Agenda Item #: 7

SUB-002741-2023 & SUB-SW-002742-2023

Magnolia Pointe Subdivision

- Subdivision approval to create three (3) legal lots of record from one (1) existing metes-and-bounds parcel; and
- Waive the construction of a sidewalk along Schillinger Road South.

SITE PLAN

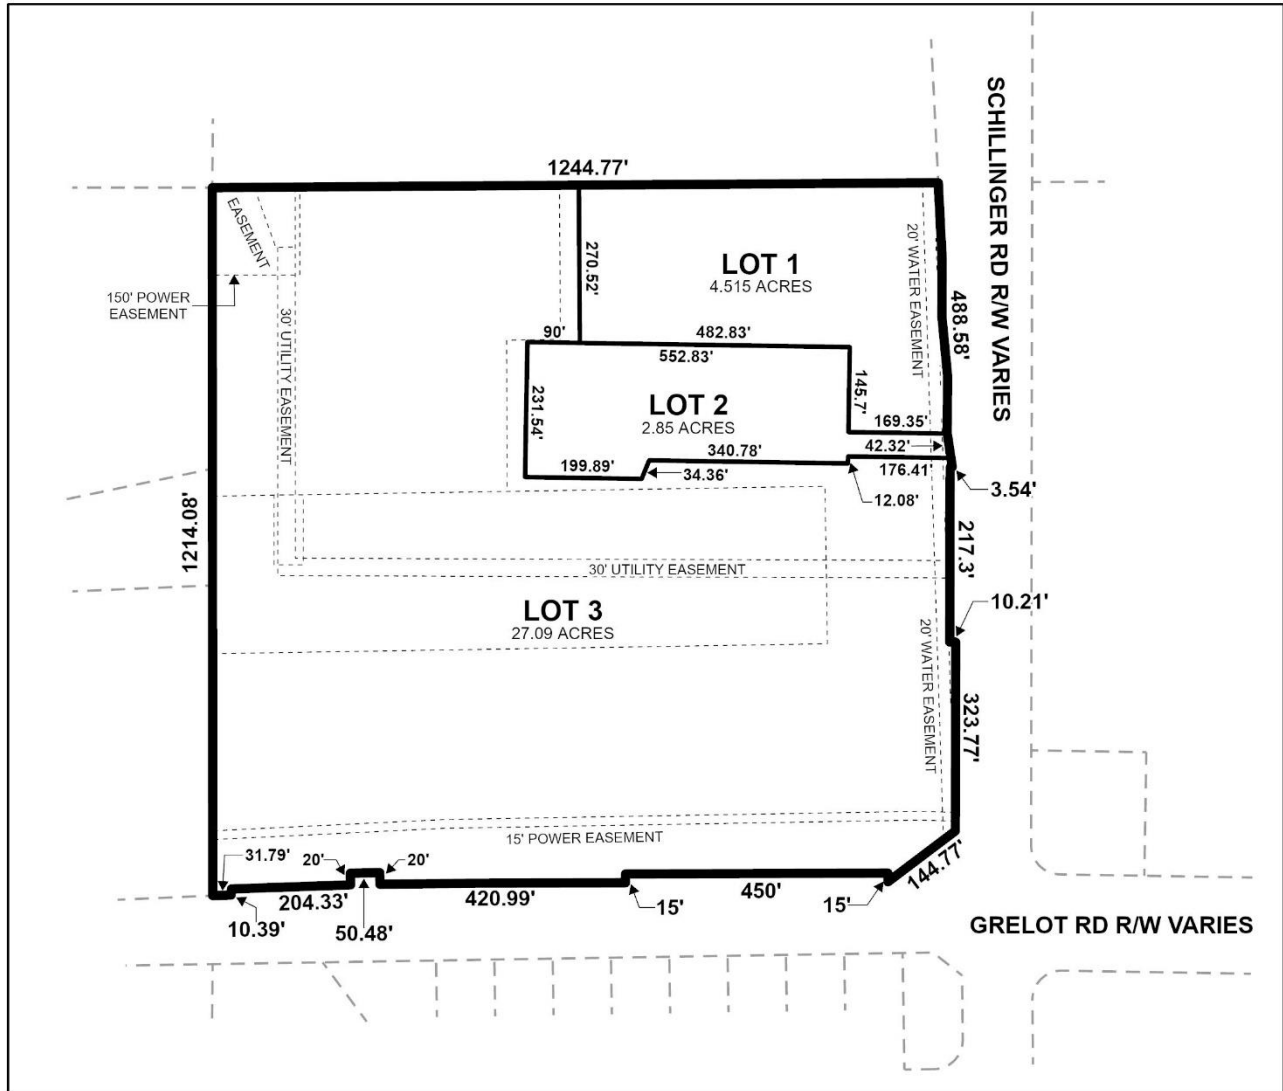
The Preliminary Plat depicts Lot 2 as an irregular, flag-shaped lot. Per Section 6.C.9. of the Subdivision Regulations, flag-shaped lots are generally not allowed. There are existing flag-shaped lots in the vicinity of the site, some of which were approved by the Planning Commission under various subdivision requests. If approved, a waiver of Section 6.C.9. will be required.

The Preliminary Plat does not illustrate compliant minimum building setback lines along any of the proposed lots. As such, the Final Plat should be revised to illustrate a 25-foot minimum building setback line along Schillinger Road South for Lot 1 and a 25-foot minimum building setback line along both Schillinger Road South and Grelot Road for Lot 3. If approved as a flag lot, Lot 2 should be revised to illustrate a minimum building setback line located 25 feet from the point where the lot “balloons” out to a minimum width of 60 feet.

As previously mentioned, Lot 3 is a corner lot and must illustrate dedication sufficient to provide a corner radius in compliance with Section 6.C.6. of the Subdivision Regulations. However, per the city Engineering Department, dedication will not be required at this time. As such, a waiver of Section 6.C.6. may be appropriate.

Lots 1, 2, and 3 contain numerous access and utility easements which should be retained on the Final Plat. Additionally, a note should be required on the Final Plat, if approved, stating that no structure may be constructed or placed within any easement without the permission of the easement holder.

4. Revision of the Final Plat to illustrate a 25-foot minimum building setback line along Schillinger Road South for Lot 1 and a 25-foot minimum building setback line along both Schillinger Road South and Grelot Road for Lot 3;

5. Revision of the Final Plat to illustrate the minimum building setback line for Lot 2 to be located 25 feet from the point where the lot “balloons” out to a minimum width of 60 feet;

6. Provision of a note on the Final Plat stating that no structure may be constructed or placed within any easement without the permission of the easement holder;
